## REMARKS

Robert Love, dated and mailed August 3, 2005

## DRAWINGS

Fig. 2

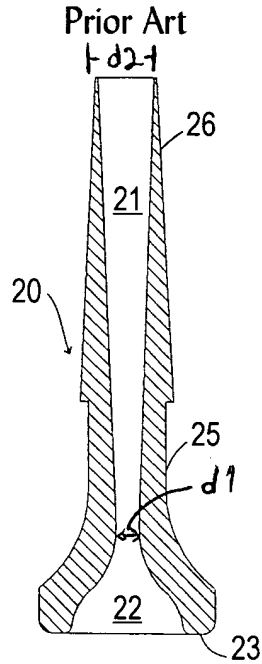
Amended drawing containing Figures 2 and 8 have PTO-suggested markings for the location of variables d1, d2, L1, and L2. Additions to Figures 4 to 7 find support in combination of the original "12-Step method", Claims 9, Claim 12, Figure 9, and the Applicant's original element numbering system.

Fig. 9

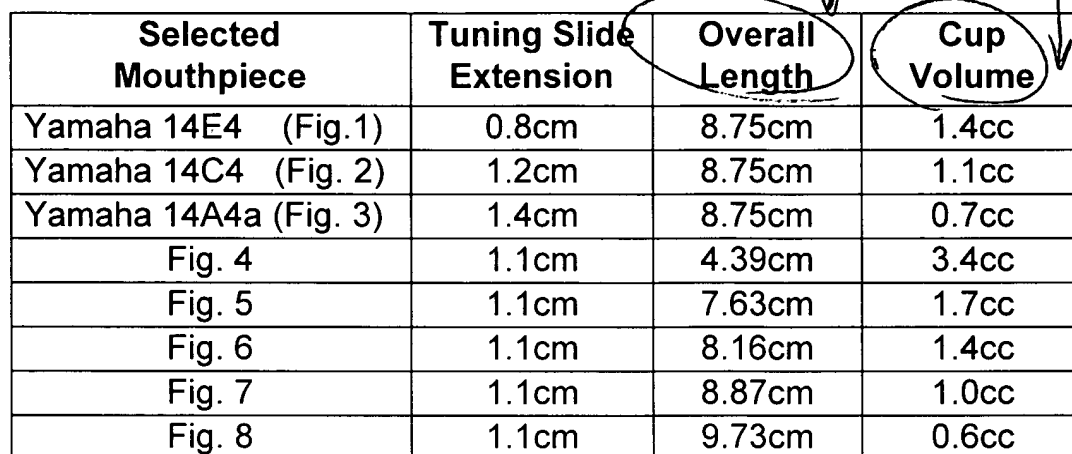
Amended drawing for Figure 9 has only symbols "v1" and "L3" placed next to prior-established written descriptions for v1 and L3 as supported by the original "12-Step method".

Fig. 10 X ~~Prior Art~~

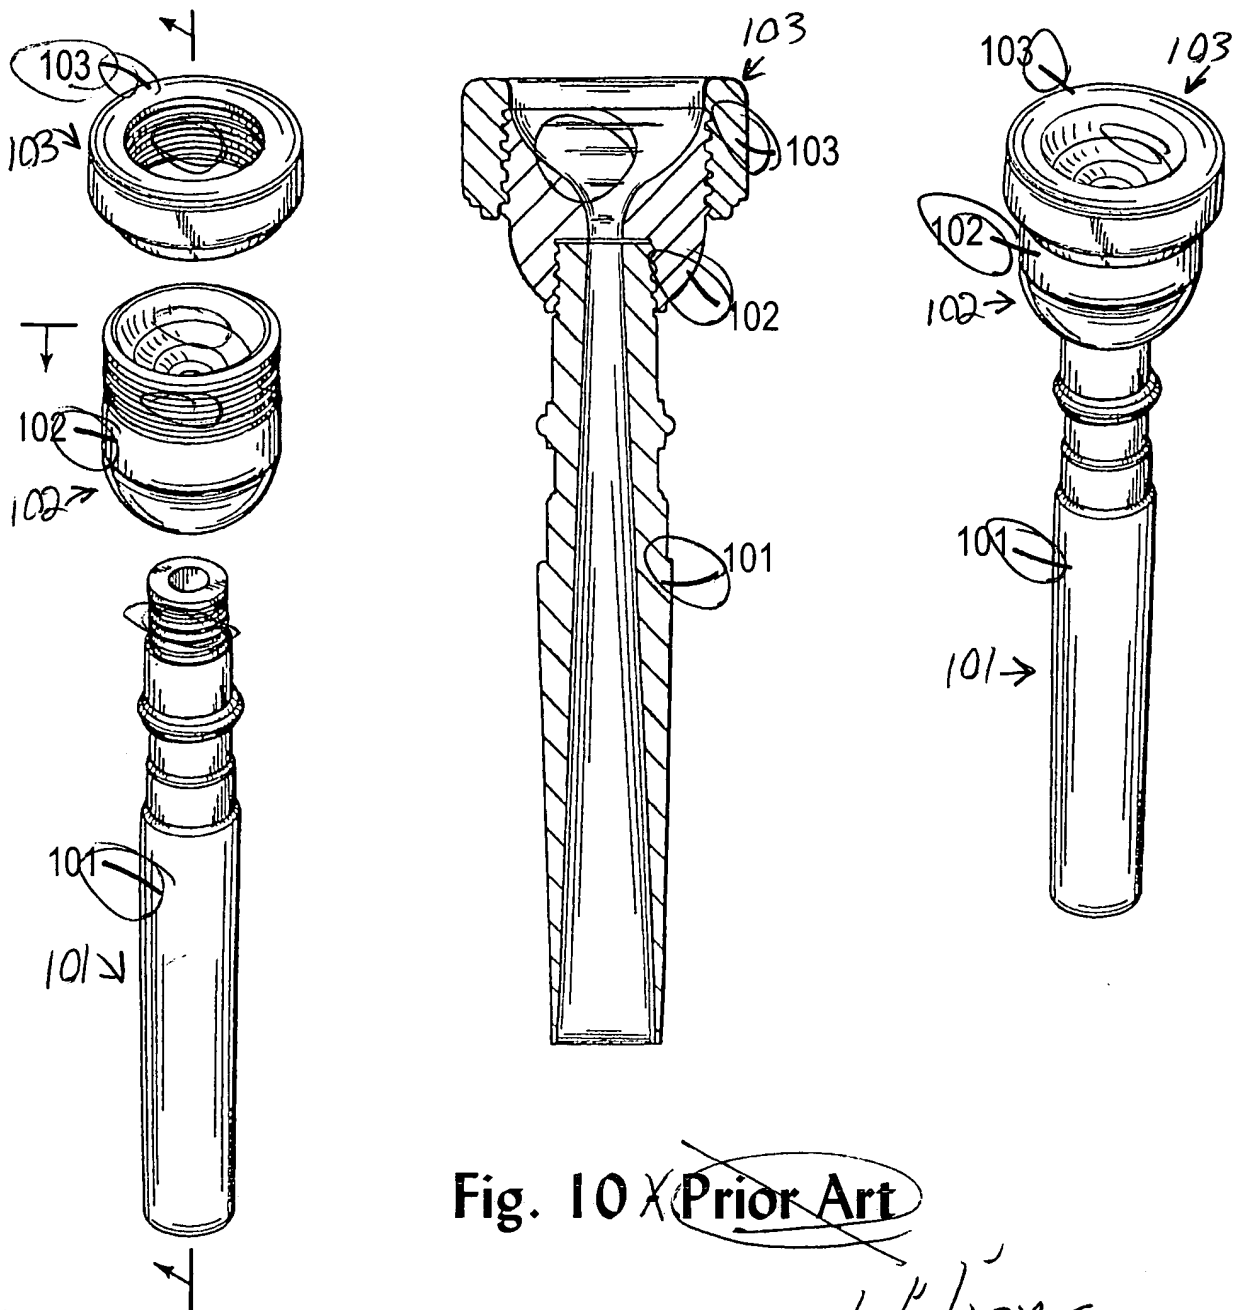
Amended drawing for Figure 10 has been corrected to present previously introduced elements (in page 17 of originally filed Specification, Claims 3, 4, & 5, and original Figure 10), for multiple views of a sectioned mouthpiece based upon original elements **81**, **82**, **83**, & **86** and using the drawing style of Shepley. The words "Prior Art" have been intentionally removed since the previously disclosed elements of page 17, Figure 8, and sections form a dependent Fortiori patentable over prior-art (based upon the novel proportions and sizes of elements **81** & **82**). Note that novel backbone length **82** is scaled much longer than the prior-art backbone originally shown as element **101**. Cup-chamber **82** also scales much shorter than shown in original Figure 10. Added element number are all supported by previously disclosed subject matter.
